Proposed Development at Old Vicarage Field, Church Road Turners Hill, West Sussex

Highway Access Arrangements

Stage 1 Road Safety Audit

Project / Document Details	
Date:	09/06/2025
Document reference and revision:	AC/TPA/0906251
Prepared by:	Alpha Highway Consultants Limited
Client	Elivia Homes
Design Organisation:	Transport Planning Associates Limited
Overseeing Organisation:	West Sussex County Council

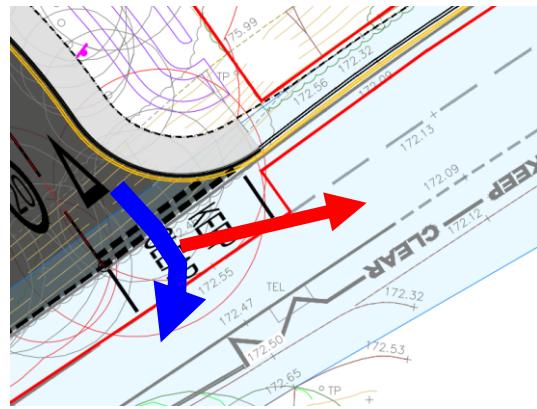
2.1 Problem

Location: Site access junction

Summary: Existing vegetation could obstruct proposed visibility splay looking west

There is currently dense vegetation in the vicinity of the proposed site access. This could obstruct the visibility splay looking west from the access junction, if not adequately cleared, potentially leading to a risk of failure to give way collisions.

It is recommended that the proposed visibility splays are cleared of any obstruction and maintained accordingly.
